Explanation of Significant Difference for the Monticello Mill Tailings (USDOE) Site Operable Unit III, Surface Water and Ground Water, Monticello, Utah

1.0 Introduction

Figure 1. Approximate Extent of the Contaminant Plume Based on Distribution of Uranium, October 2007

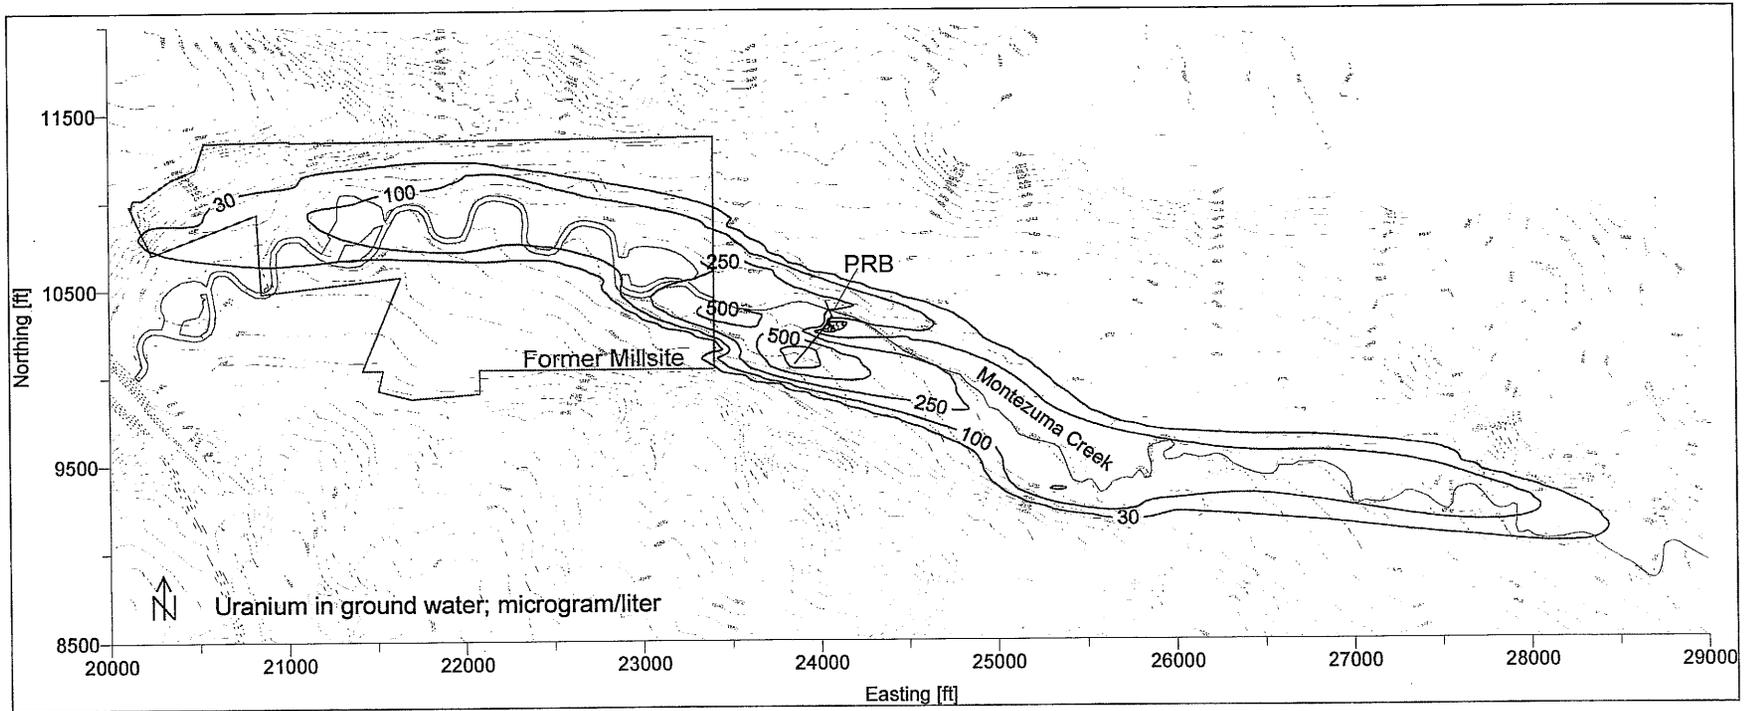
Figure 1 indicates the approximate extent of the contaminant plume based on the distribution of uranium. Plumes for other constituents are much less extensive. With few exceptions (principally uranium), only wells hydraulically upgradient of the PRB have COC concentrations that exceed established standards or benchmarks. Uranium is the most pervasive site-related contaminant and is the primary COC. In addition, uranium is the indicator for determining restoration performance.

Figure 2. Treatment System Location

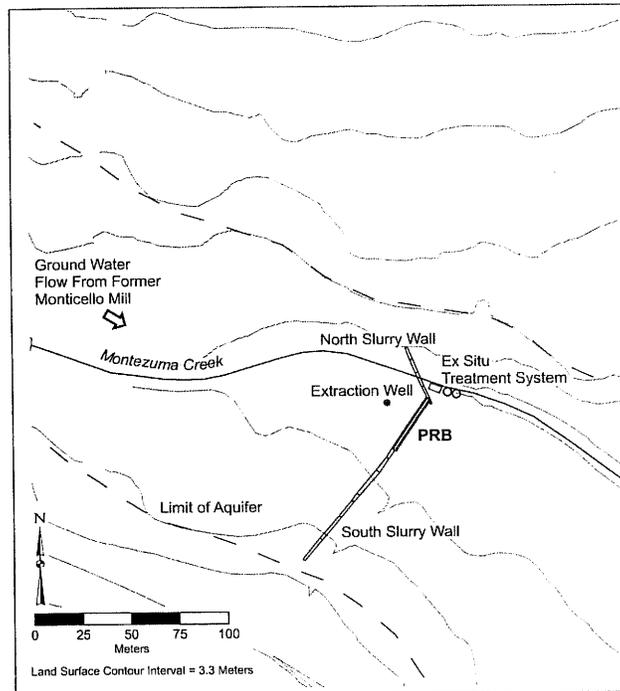
- A pump-and-treat enhancement installed near the PRB as part of a DOE Office of Legacy Management and EPA treatability study will become a component of the contingency remedy for OU III. The contingency remedy evaluation will include operation of the pump-and-treat enhancement upgradient of the existing PRB to evaluate the potential long-term effect of active restoration in reducing contaminant mass and achieving applicable or relevant and appropriate requirements (ARARs). This treatment enhancement may include evaporative treatment and continued treatment with the existing ex situ treatment cells. The treatment will continue until remedial action objectives are met or another remedy is selected. DOE recently met all substantive requirements allowing discharge of treated ground water directly to Montezuma Creek.

- The PRB wall, or a replacement facility that will continue to capture ground water if DOE decides to go forward with decommissioning of the permeable reactive gate, will become part of the remedy. The PRB was designed to allow ground water to flow through and immobilize uranium and other contaminants on zero-valent iron, the reactive medium. However, mineralization within the PRB has significantly reduced its capacity to transmit ground water. To date, the PRB is serving as a barrier to ground water migration and is part of the overall strategy to capture and treat the ground water. DOE will pursue aquifer dewatering using the pump-and-treat enhancement to reduce ground water mounding in preparation for PRB removal.
